# Flooding & Stormwater Management Planning Report

## Proposed Planning Proposal

1-5 Chester Street  
Annandale NSW 2038  
Lot 11 DP499846

**Re: 1-5 Chester Street, Annandale NSW – Planning Proposal – Response to Council Flooding Comments**

## Annexure A – Amended Conceptual Architectural Section

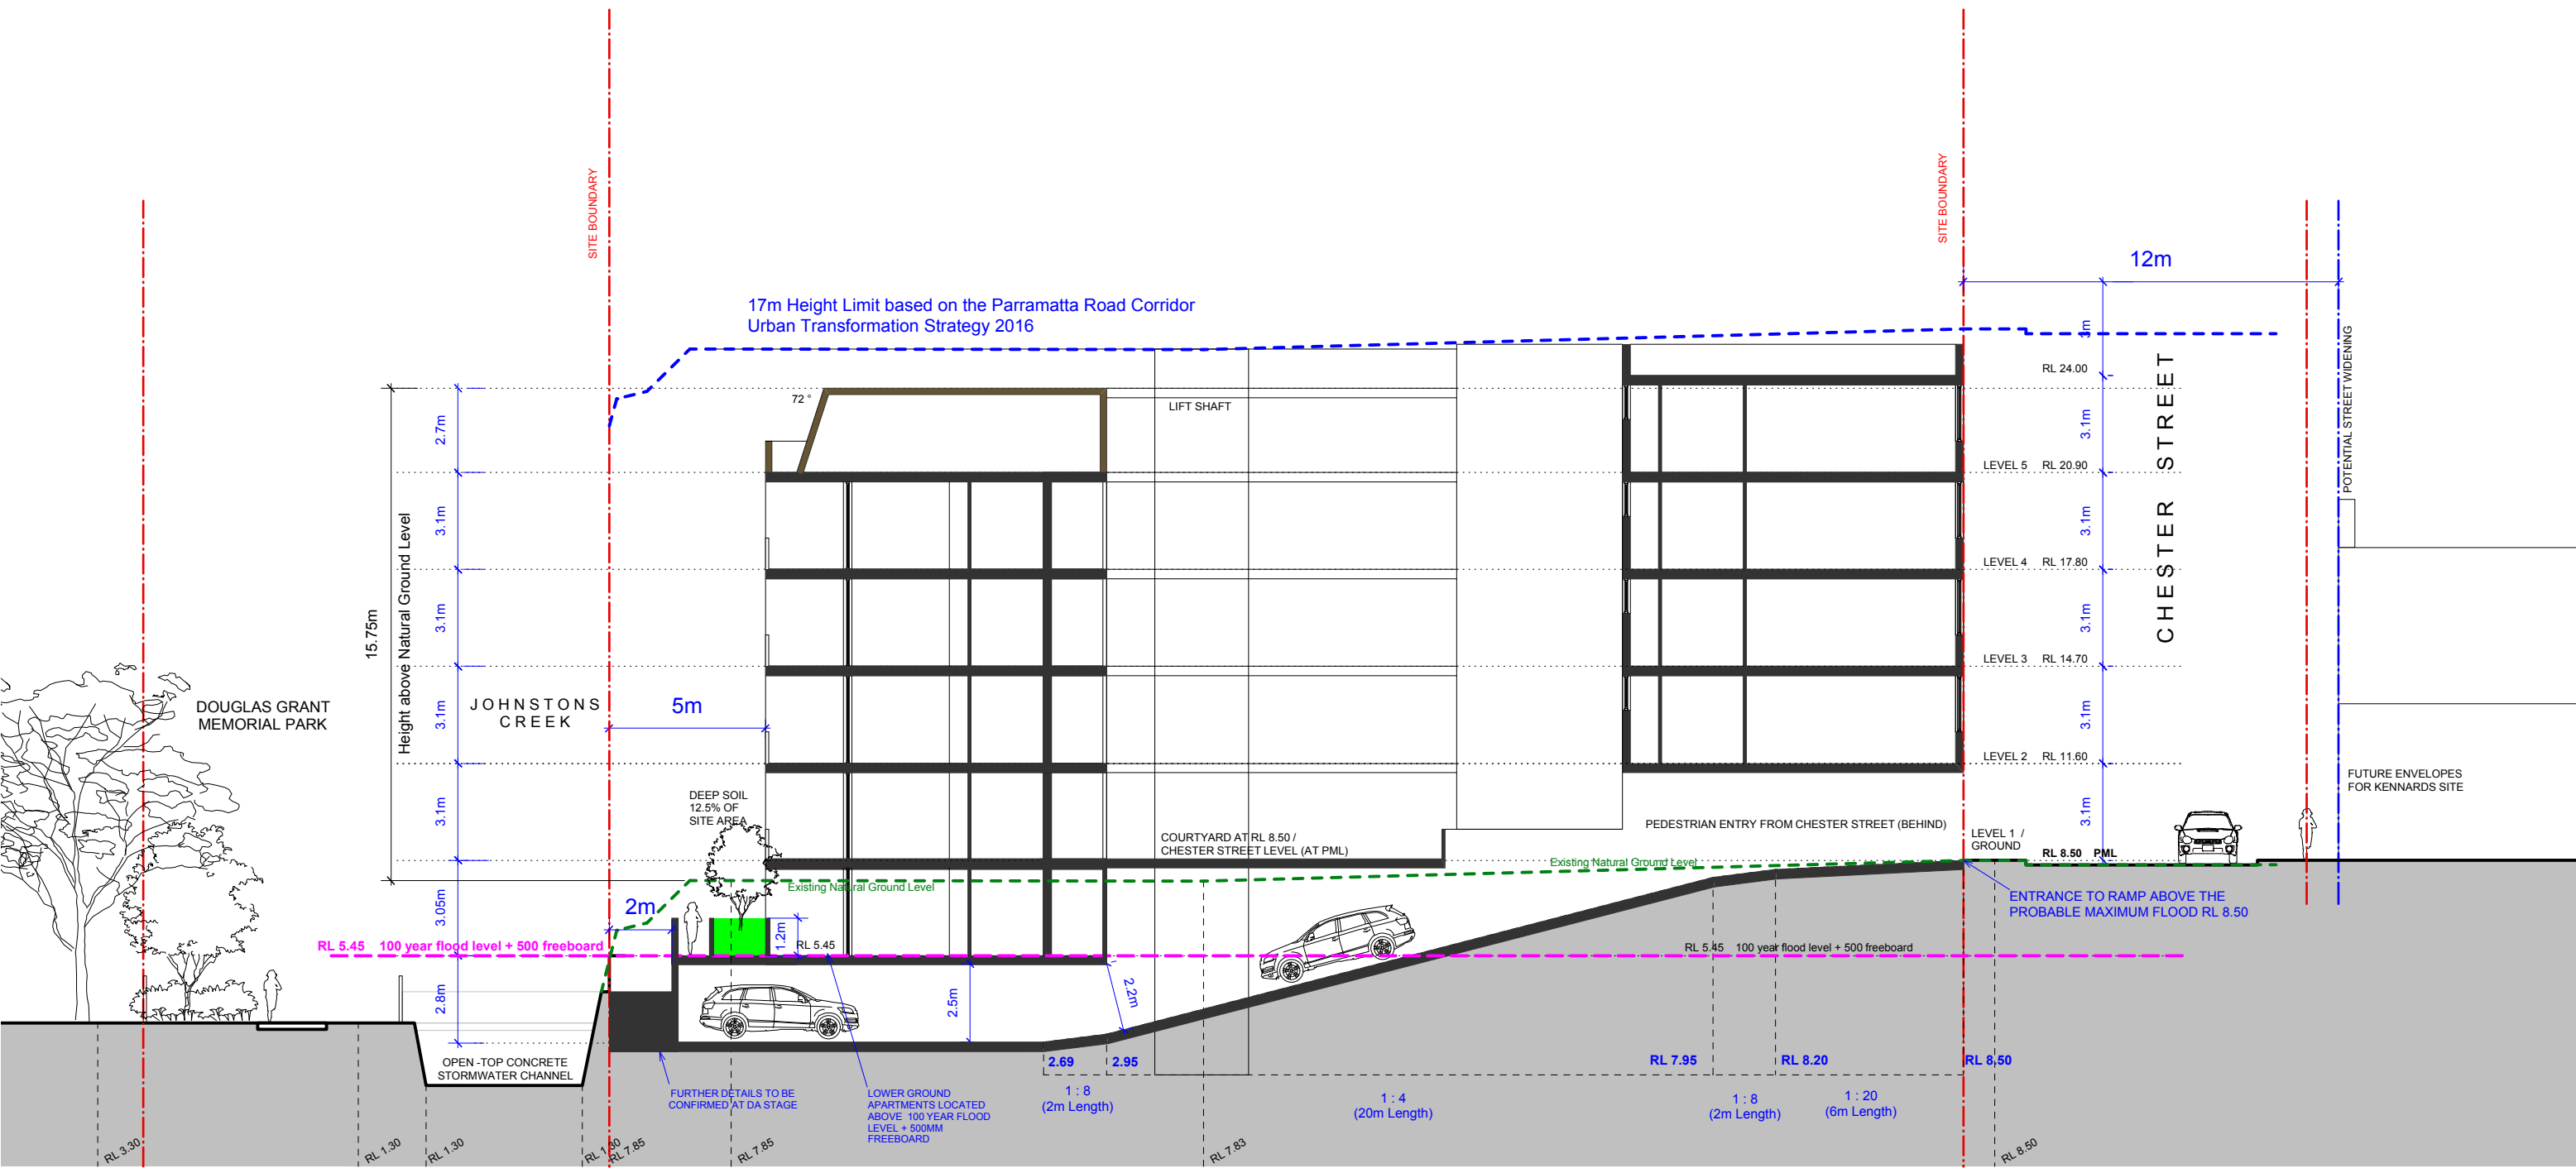
Whilst the proposed western boundary wall could provide the required protection to the development, it would remove flow	It is generally agreed that the undercroft area of the existing development does appear to provide flood conveyance in

<p>capacity alongside the Johnstons Creek channel. This would cause an increase in flows and depths beyond the subject site which absolutely cannot be accepted. Consequently any fence on or close to the boundary would need to be an open style. There should be no solid wall protruding above the existing channel wall within the setback area, including that shown in the UDR cross sections as the upper rear wall of the basement car park.</p>	<p>major storm events, which is partly evidenced by the Cardno flood study that has been undertaken. As the current design is conceptual only and for planning proposal purposes only, a detailed assessment of flooding impacts would be undertaken at a detailed DA submission stage to ensure there are no detrimental effects to upstream and downstream properties and that the existing flooding regime is maintained. To convey this intent revised conceptual architectural plans have been prepared and are located in annexure A for reference.</p>
